<p style="text-align: center;"> • MANUFACTURERS OF WIPLINE FLOATS & SKIS • SPECIALISTS IN AIRCRAFT MODIFICATION </p> <p style="text-align: center; font-size: small;"> 1700 Henry Avenue - Fleming Field South St. Paul, MN 55075 651-451-1205 </p>			Rev
			Date 6/1/07
Prepared by Ellen Parker	Aircraft Make / Model Cessna 208 Caravan	Float / Ski Model 8000 Amphibious floats S/N 80323 & 80324.	Page 1 7
FAA Reviewed <input checked="" type="checkbox"/>	Title Slide Tube End Machining Repair		
ALL INFORMATION IN THIS SERVICE DOCUMENT BASED ON FAA APPROVED DATA

SERVICE LETTER: 95

MAIN GEAR SLIDE TUBE ASSEMBLY
FIGURE 11

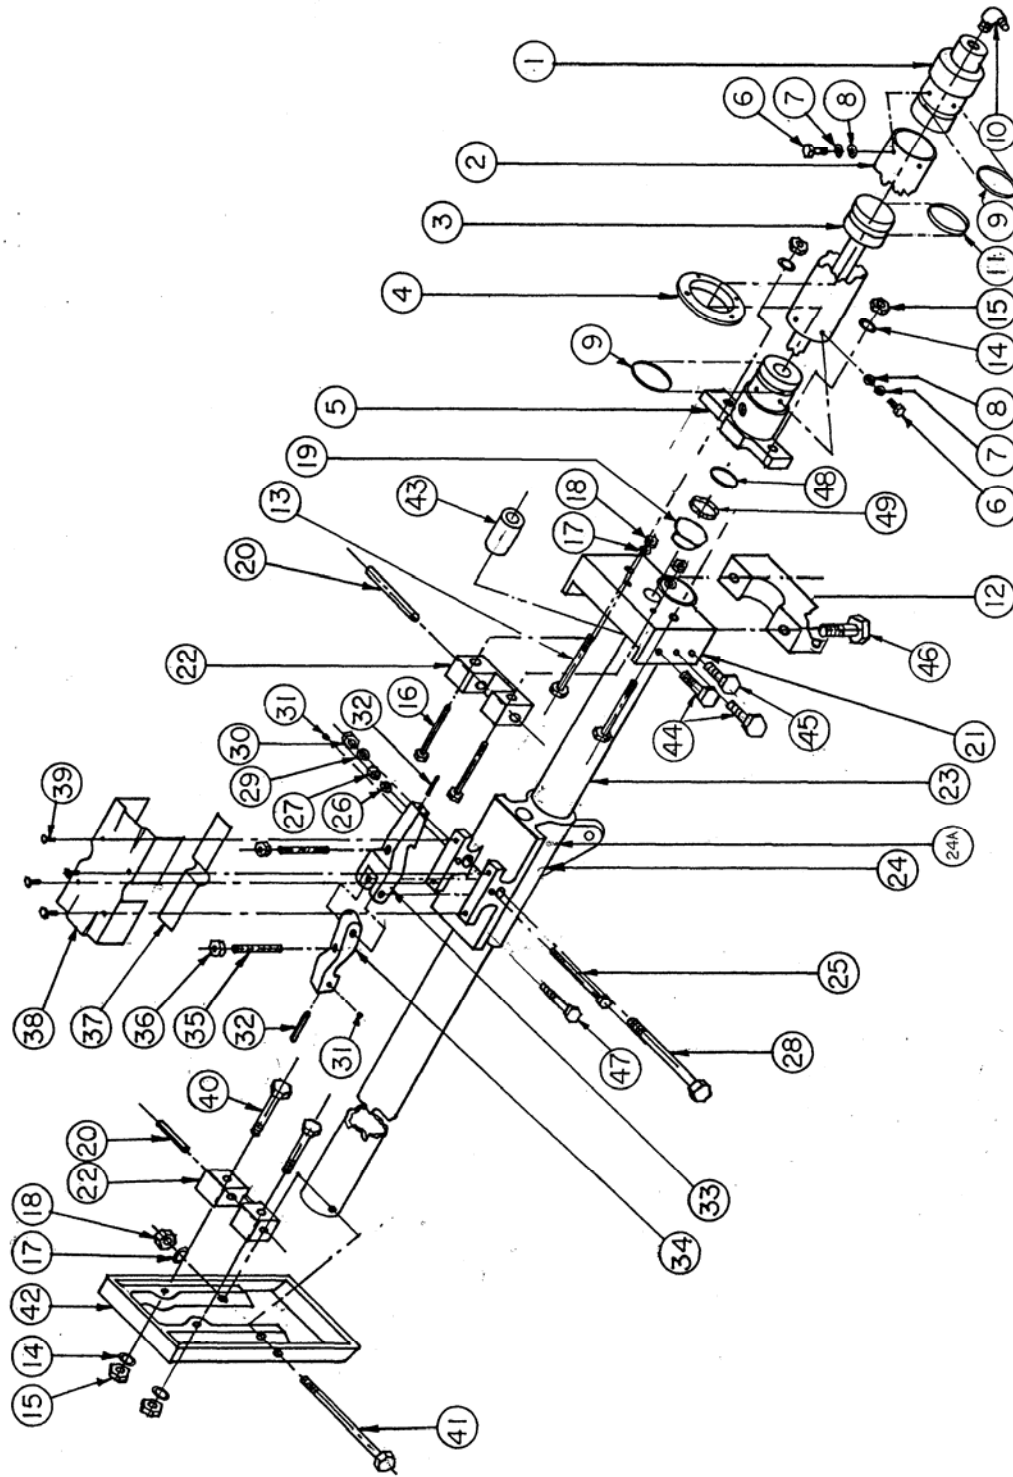
BACKGROUND INFORMATION: A small number of Part # 6A01201-001 (Figure 11, item 42 in Parts manual) were out of tolerance. All parts that were out of tolerance were located and replaced appropriately before customer delivery of floats with the exception of one set. S/N 80323 & 80324.

Remove AN-6-47A bolt (Figure 11, item 41 in parts manual) use NAS1149F0663P & NAS1149F0632P washers as spacers to ensure slide tube is centered and remains centered.

Picture 1

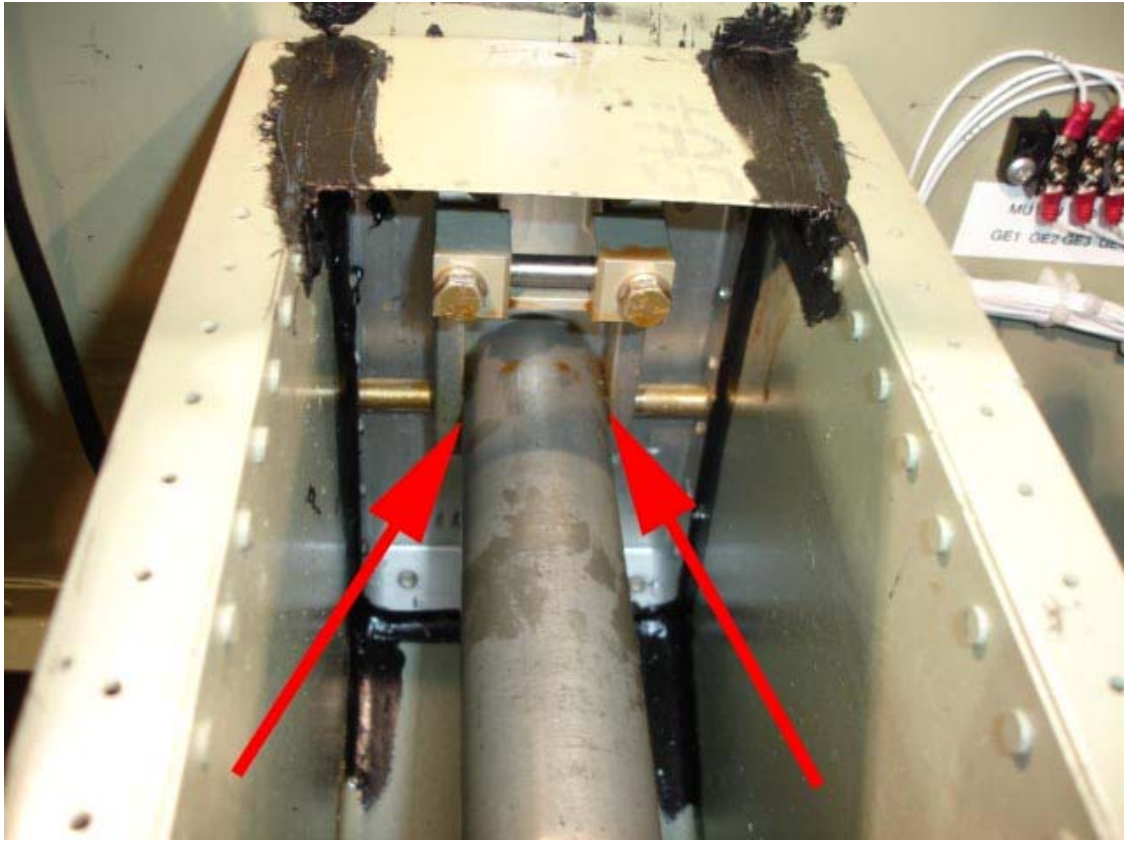
This error leaves a small gap between the slide tube and the ears of the machining the slide tube is bolted to (see red arrows). Due to the fact that the aircraft is in operation, this temporary repair will allow continued operation until final repairs can be made.

Look for gap between slide tube & 6A01201-001 ears (see arrows on Picture 1, picture shows assembly as it should be with no gap).

If gap exists:

Jack or lift aircraft per Service Manual methods.

Re-assemble

Perform gear swing test per service manual to ensure proper gear functionality.
